REMARKS

Applicant's invention, as disclosed and claimed (for example, by independent claim 3 and substantially similarly by independent claims 5, 6, and 11), is directed to a semiconductor device.

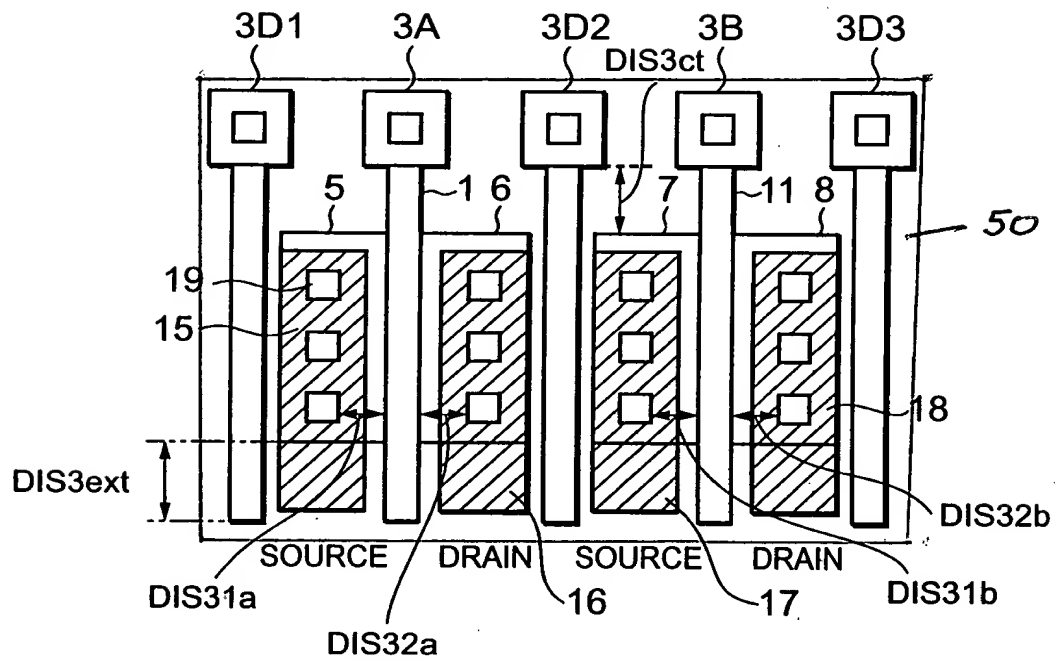
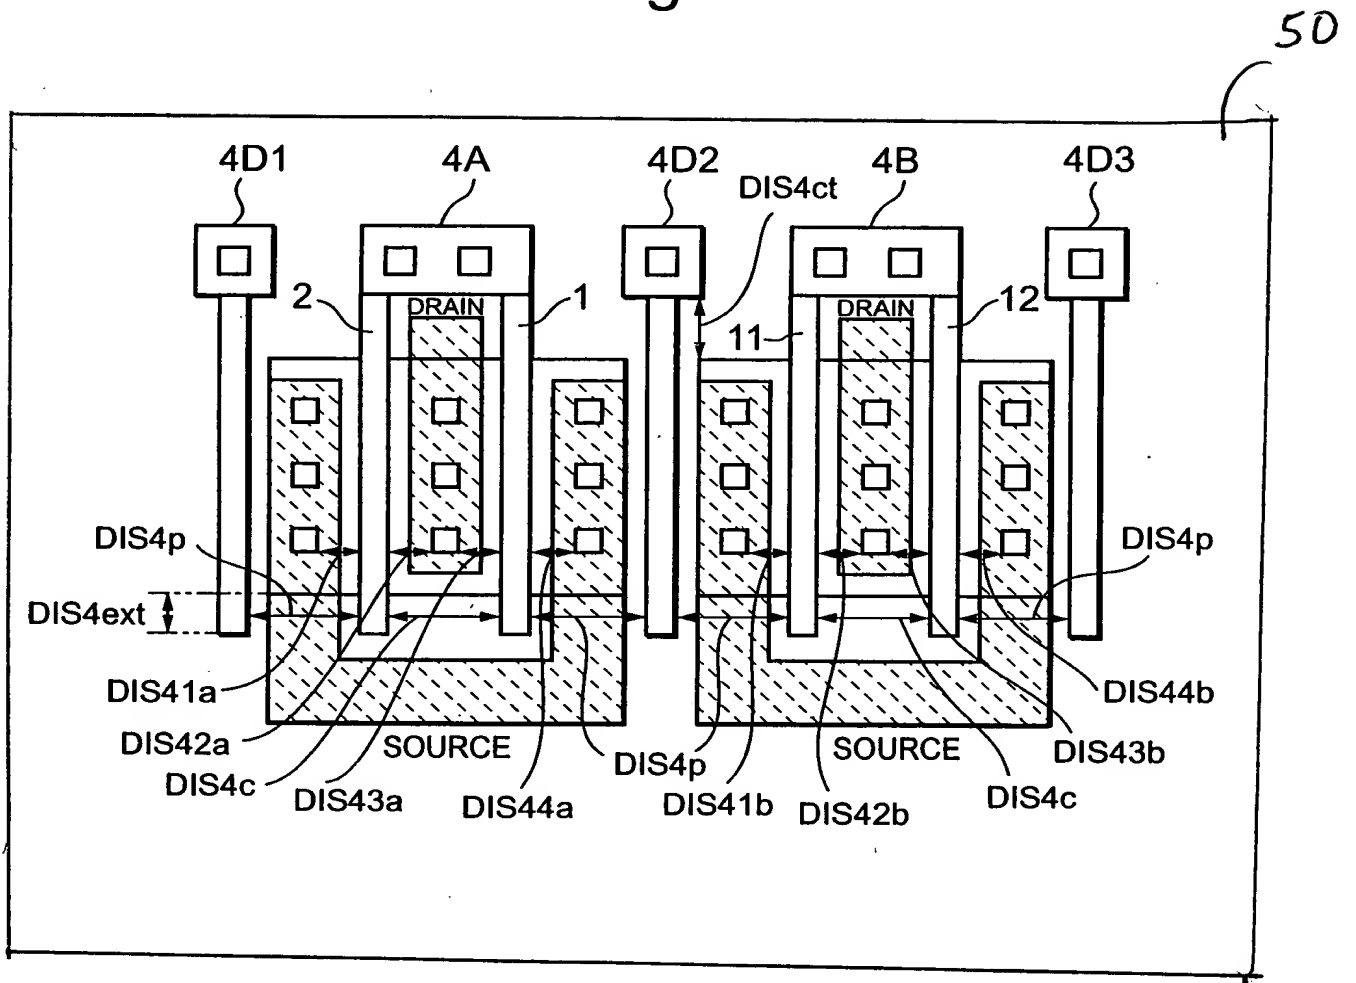
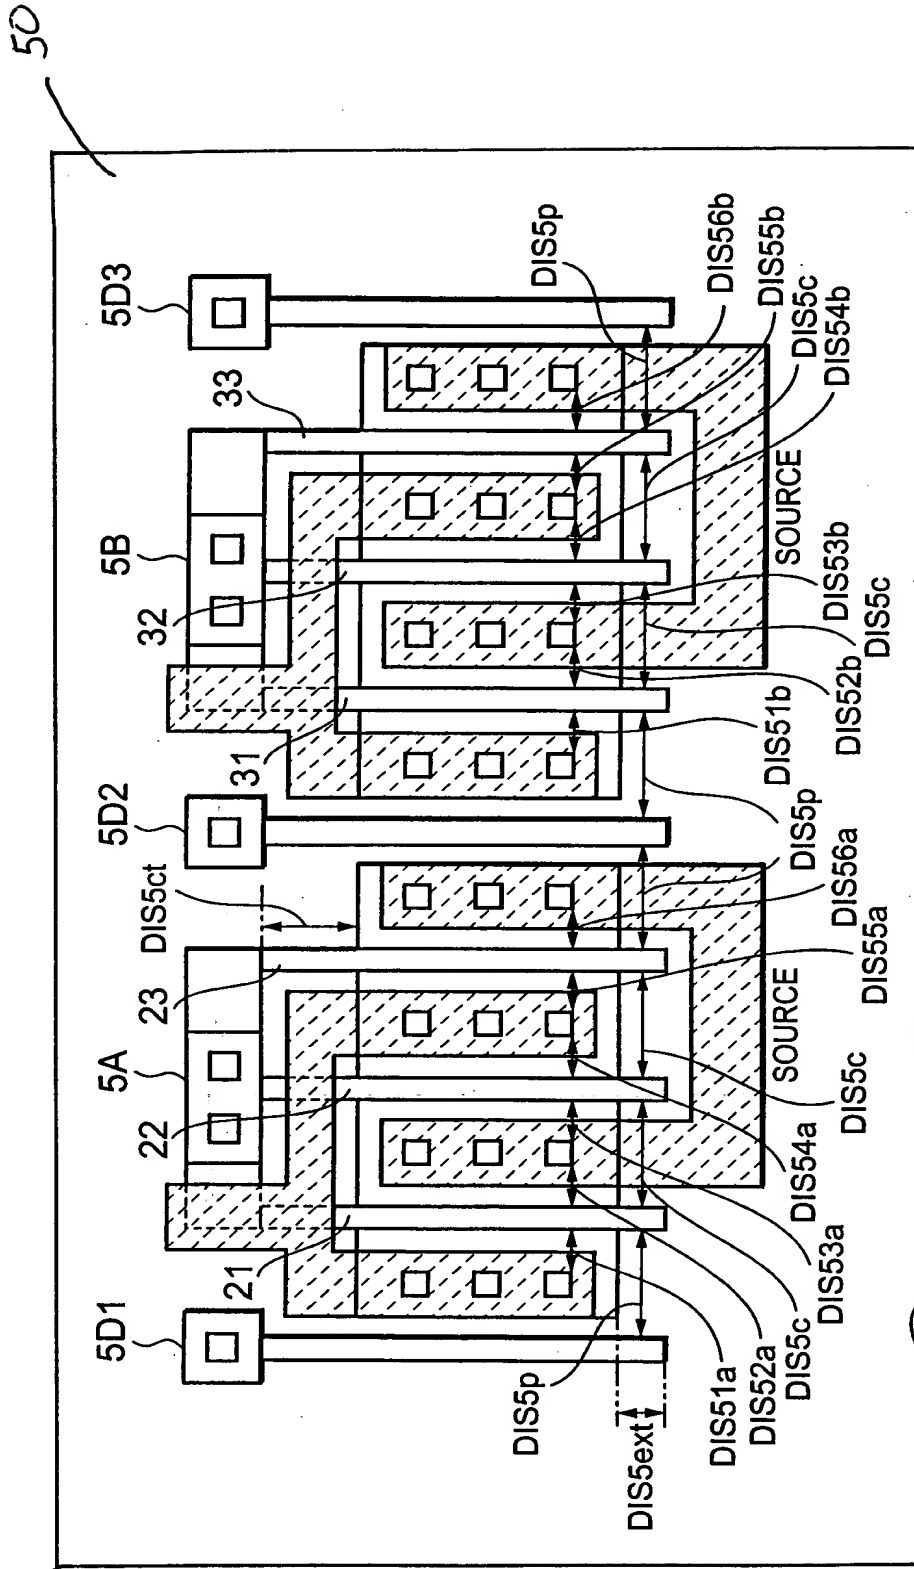
In response to the Examiner's objection to the Drawings, Applicant files herewith a Submission of Proposed Drawing Corrections for Figs. 1-3 marked in red to show an element isolation region 50. Further, Figs. 6-8 have been marked in red and labeled as "Prior Art". Further, in response to the Examiner's objection to the Drawings (e.g., on page 2, item 3 of the Office Action), Applicant respectfully notes that the specification has been corrected in the Amendment filed on November 26, 2001 to clearly identify the source diffusion region 7.
